PRELIMINARY SITE GRADING CONSTRUCTION PLANS  
FOR  
**CREEKSIDE SOUTH AT LORSON RANCH**  
EARLY OVERLOT GRADING / EROSION CONTROL PLANS

**COVER SHEET**  
**EARLY GRADING AND**  
**EROSION CONTROL PLAN**

DATE: **MAY 12, 2020**  
PROJECT NO. **100.051**  
SHEET NUMBER **C0.1**  
TOTAL SHEETS: 15

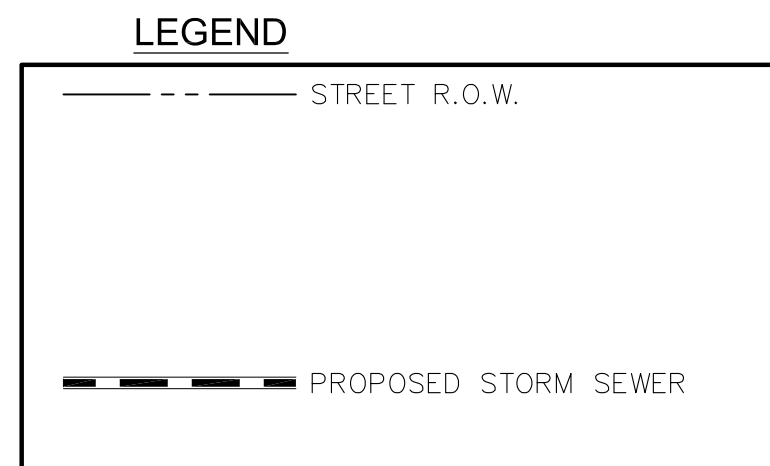
Update to state the following:  
County plan review is provided only for general conformance with County Design Criteria. The County is not responsible for the accuracy and adequacy of the design, dimensions, and/or elevations which shall be confirmed at the job site. The County through the approval of this document assumes no responsibility for completeness and/or accuracy of this document.

Filed in accordance with the requirements of the El Paso County Land Development Code, Drainage Criteria Manual Volumes 1 and 2, and Engineering Criteria Manual, as amended.

In accordance with ECM Section 1.12, these construction documents will be valid for construction for a period of 2 years from the date signed by the El Paso County Engineer. If construction has not started within those 2 years, the plans will need to be resubmitted for approval, including payment of review fees at the Planning and Community Development Director's discretion.

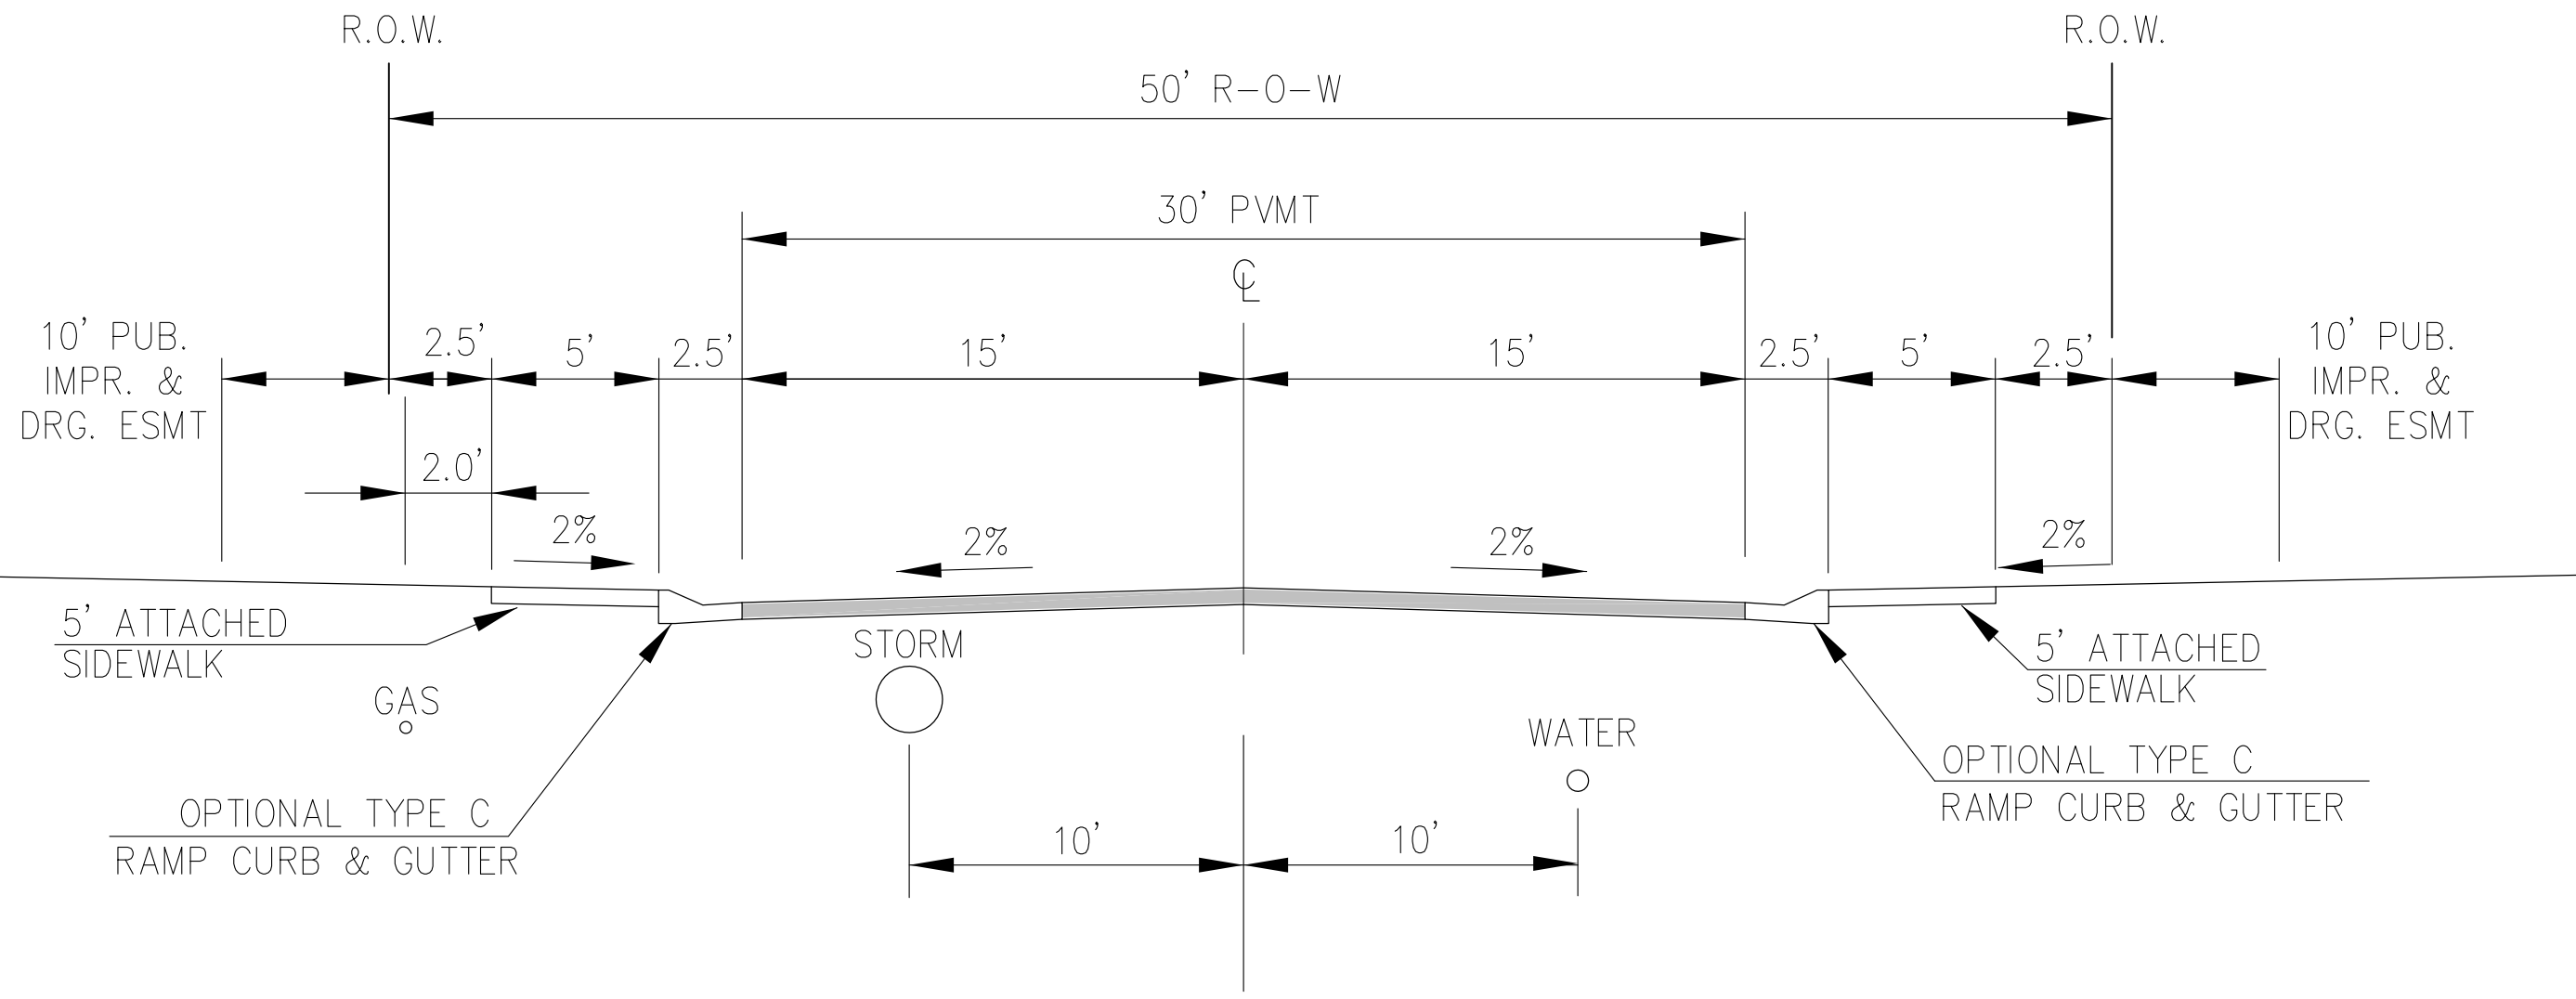
There is a reference to a 12" pipe with the FMIC ditch; is this pipe to be removed? (What are extents?)

**LEGEND**

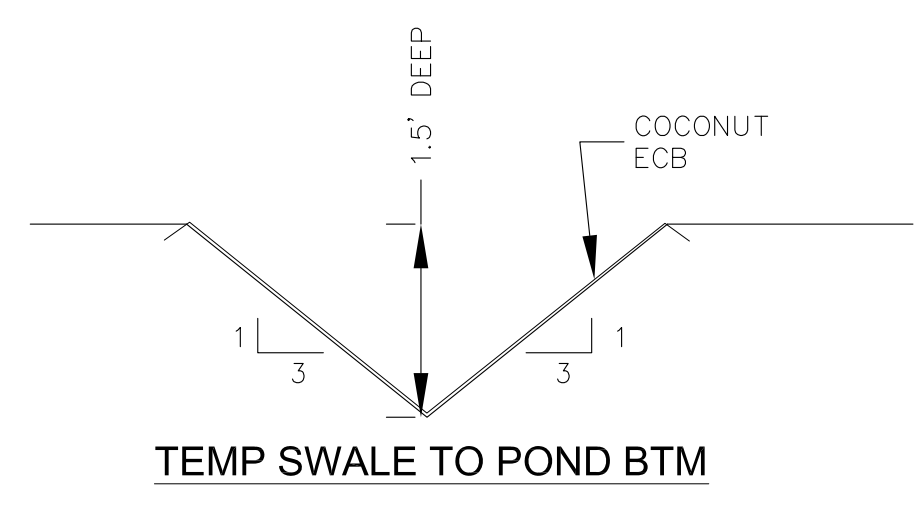
These should be 3 different symbols
